## Reviewer 1

Your paper tries to assess the sensitivity of the Fitch scheme in wake simulations by implementing it on a newly developed PBL scheme. I am certain that this manuscript is interesting and has some value but I am not sure whether in its actual state displays correctly this value, since I think the reader cannot gain much from all the numbers you reach with your simulations. So in the following, you find a list of major and minor/specific comments.

Response Figure 1. The page-long 3DPBL equations, as documented in Juliano et al (2022).

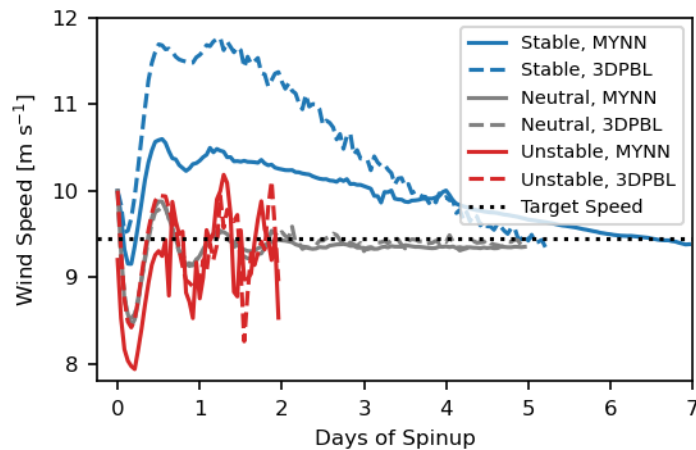
3. Second paragraph in Sect. 2.1: these lines should be complemented with the formulations so that the reader can get an idea of the advantages/extensions of the 3D TKE PBL.

Thank you for this suggestion. We wanted to do include the 3DPBL formulations in the initial draft of the manuscript, but we ultimately omitted copying the formulations from Juliano et al. (2022) to this paper, as the matrix equations in the original paper take up an entire page (Ref. Fig. 1). We include the reference to the paper with these formulations. Instead, we qualitatively and quantitatively discuss the major differences between the two PBL schemes in the manuscript (L109-133).

Response Figure 2. Figure 2 in the updated manuscript. Hub-height wind speed at the center of each domain during spin-up in the idealized turbine-free simulations. The last 24 hours of each simulation is taken as the performance period for the NWF simulations.

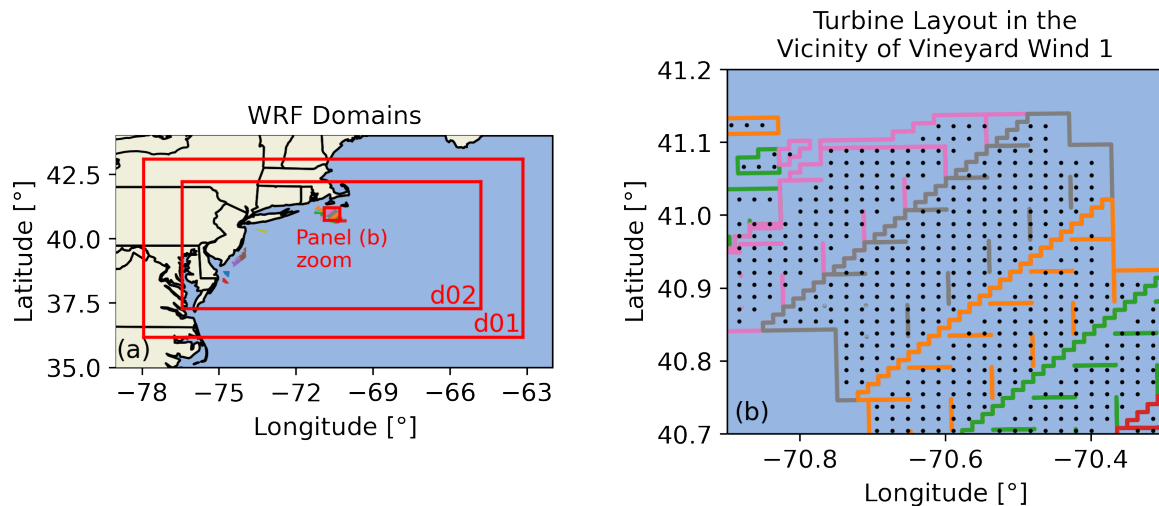
- Text between lines 198 and 208: due to the use of a new PBL scheme, it would be interesting to see the development with time of the turbine-free simulations and find out why 3 days are indeed needed to develop the ABL and reach quasi-steady state (it just reads as a quite extremely long spin up period). By the way, you do not

mention (I think) the type of boundary conditions during spin up and wake simulations.

Thank you for the suggestion. We have added a section discussing the spin-up of the simulations at the start of Section 3.1 (L235-242).

The boundary conditions for the idealized simulations during spin-up can be found in the updated Table 1. We now explicitly state that the wake simulations use the same boundary conditions as the turbine free simulations (L184).
